Staff Report: PHO-2-23--Z-73-01-6(8)

<u>APPLICATION #:</u>	PHO-2-23--Z-73-01-6(8)
<u>LOCATION:</u>	Approximately 275 feet south of the southwest corner of 32nd Street and Baseline Road
<u>EXISTING ZONING:</u>	MUA BAOD
<u>ACREAGE:</u>	4.6
<u>REQUEST:</u>	<ol style="list-style-type: none">1) Request to modify Stipulation 1.a regarding general conformance with the site plan dated August 27, 2001.2) Request to modify Stipulation 1.b regarding a detached sidewalk.3) Request to delete Stipulation 1.c regarding commercial building height.4) Request to modify Stipulation 1.d regarding a Homeowners Association.5) Request to modify Stipulation 1.f regarding interior perimeter walls.6) Request to delete Stipulation 1.g regarding parking stalls.7) Request to delete Stipulation 2.1a regarding commercial building elevations.8) Request to modify Stipulation 2.2a regarding one-story houses.9) Request to modify Stipulation 2.2b regarding floor plans.10) Request to delete Stipulation 3 regarding Streets and Rights-of-Way.11) Request to modify Stipulation 4.a regarding a 25-foot easement on the west side of 32nd Street.12) Technical corrections to Stipulation 4.b.13) Request to modify Stipulation 5.

PRELIMINARY SITE PLAN
FOR

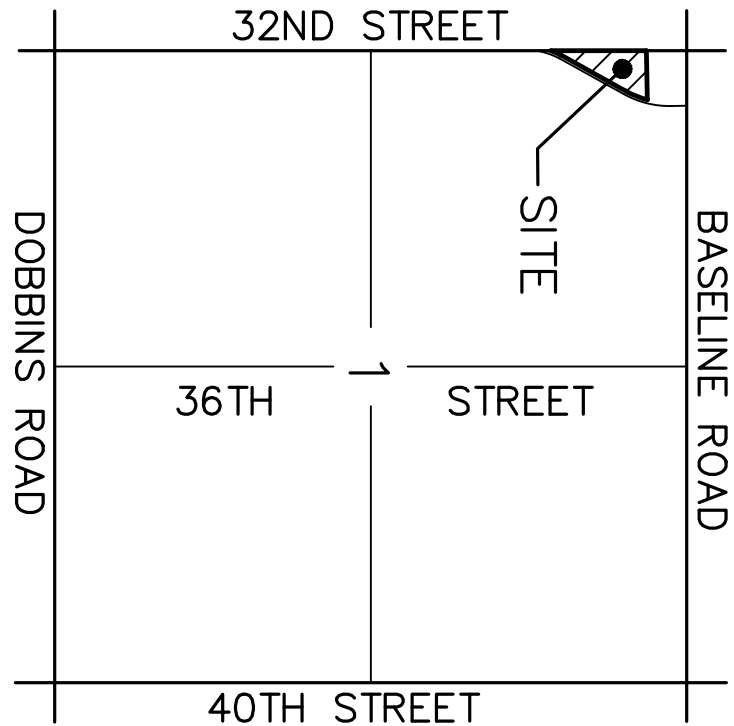
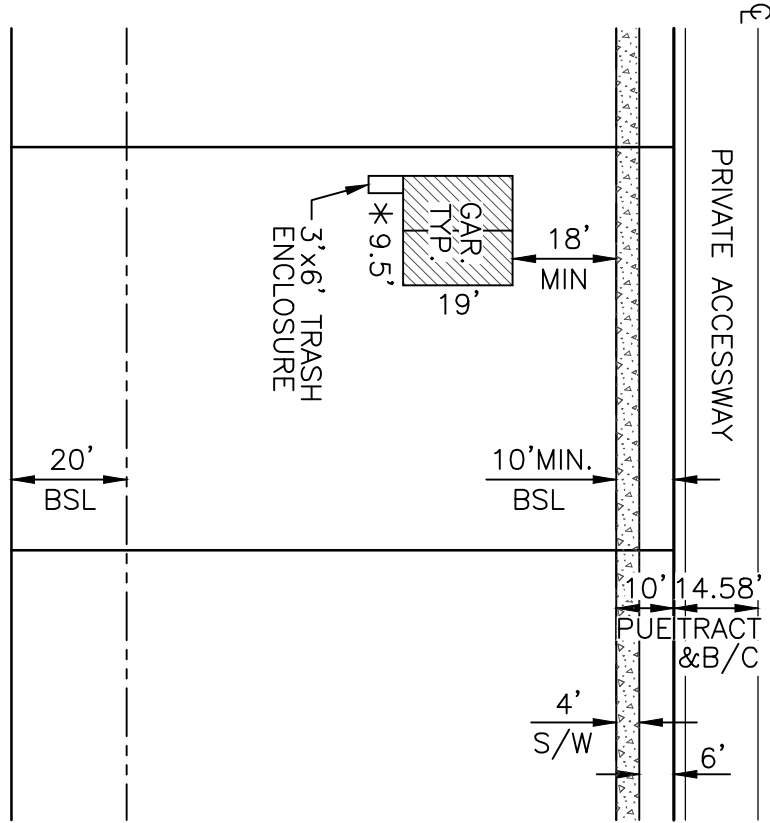
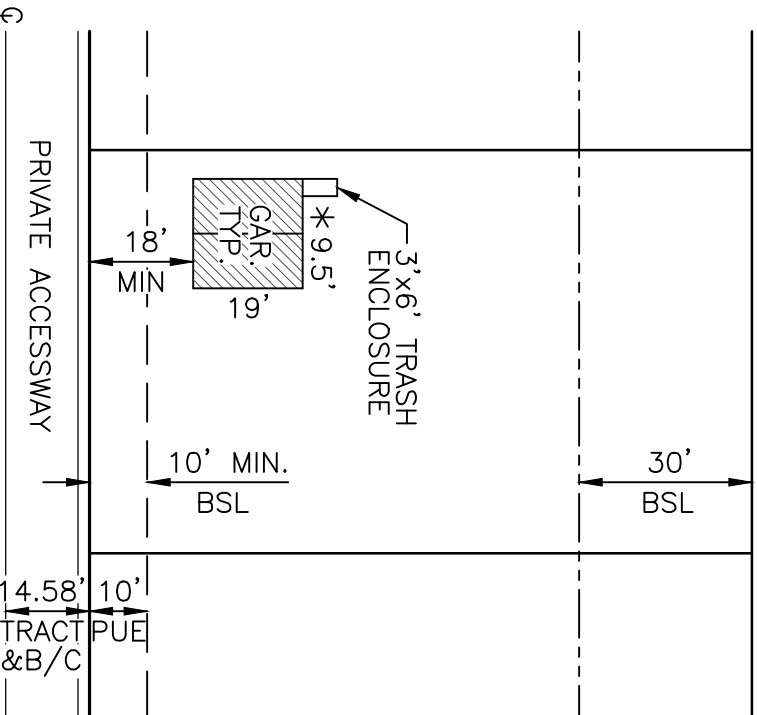
Rationale: *This application requests approval of a revised site plan for the subject property south of the SWC of 32nd Street and Baseline Road. The new site plan retains the open space shown on the August 27, 2001 approved site plan and will continue to support the stipulated open space from case Z-73-01. However, the specified open space elements addressed in the dot points are in the now-built residential project on the east side of 32nd Street and have no applicability to the parcel under this application.*

Rationale: *The small size and irregular shape of the subject parcel limits the ability to provide, and need for, detached sidewalks on both sides of the private street. All homes will have easy access to the detached sidewalk proposed for the east portion of the project to access the open space area and to exit the neighborhood to 32nd Street.*

1.	Site Planning:	
	a.	<p>That The development shall be in general conformance with the site plan and landscape plan dated STAMPED NOVEMBER 1, 2023 August 27, 2004, AS APPROVED OR MODIFIED BY THE FOLLOWING STIPULATIONS AND APPROVED BY THE PLANNING AND DEVELOPMENT DEPARTMENT. with specific regard to areas to be counted towards approximation of the 50% open space requirements in the MUA as may be approved by DSD, and represented by:</p> <ul style="list-style-type: none"> • A circular open space tract in the residential area. • Linear pedestrian tracts in the east and south connecting to adjacent properties. • A pedestrian link from the residential to the commercial areas in the north and crossing 32nd Street.

b.	<p>A DETACHED SIDEWALK, SEPARATED FROM THE CURB BY landscaped tree lined strips that run SHALL BE PLACED along both sides ONE SIDE of all local THE PRIVATE STREETS, AS APPROVED BY THE PLANNING AND DEVELOPMENT DEPARTMENT in the residential area. This landscaped strip shall include a meandering sidewalk as shown on the site plan.</p>

Open Space Comparison

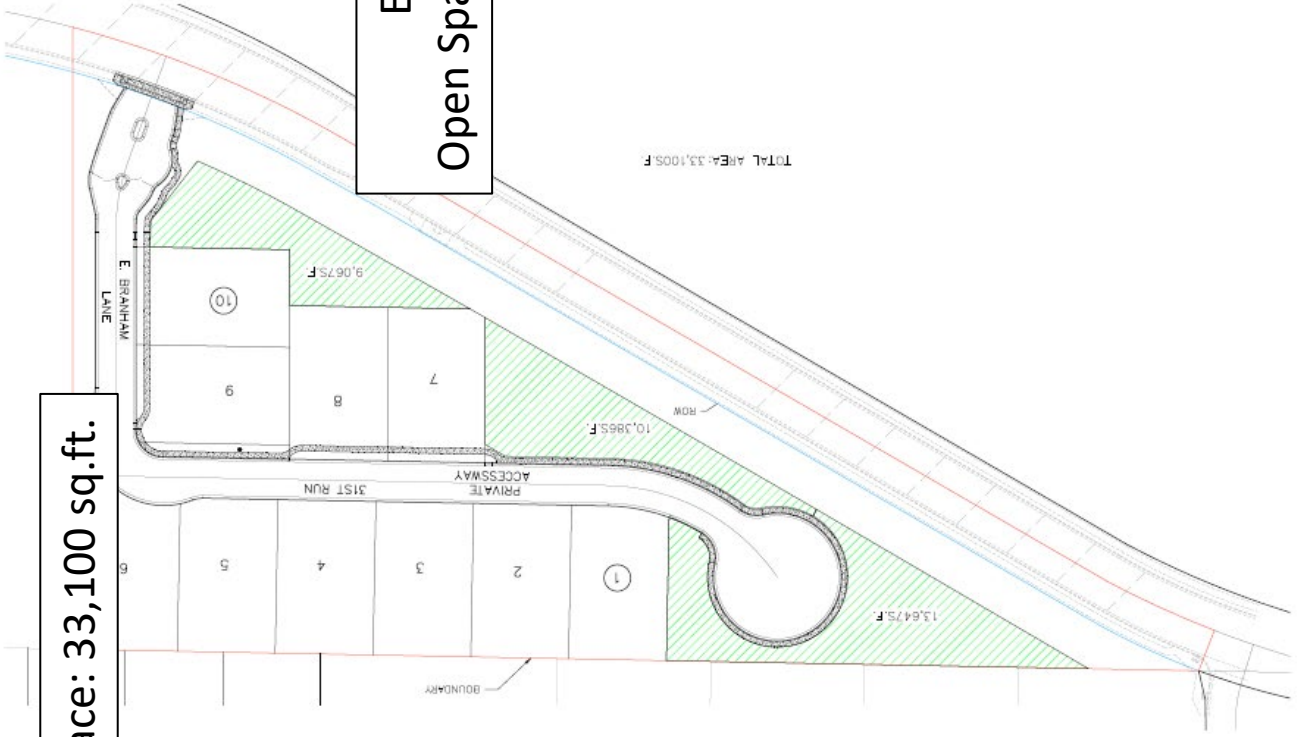
- Density, with 10 lots on 4.62 gross acres, is 2.16 du/acre – within the 2.25 limit shown on the approved site plan.
- Open space of 33,100 square feet – within 105 square feet of the approved open space for the Property and in roughly the same configuration.
- At least 30 percent of the homes shall be single-story – as stipulated in 2001.
- Home elevations shall be reviewed by the South Mountain Village Planning Committee.
- No solid fencing shall be placed along 32nd Street – as stipulated in 2001.
- The neighborhood gate shall be subject to PHO review – as stipulated in 2001.
- An alternative paving/dustproofing surface shall be provided where the private street for the Property crosses the equestrian trail – as stipulated in 2001.
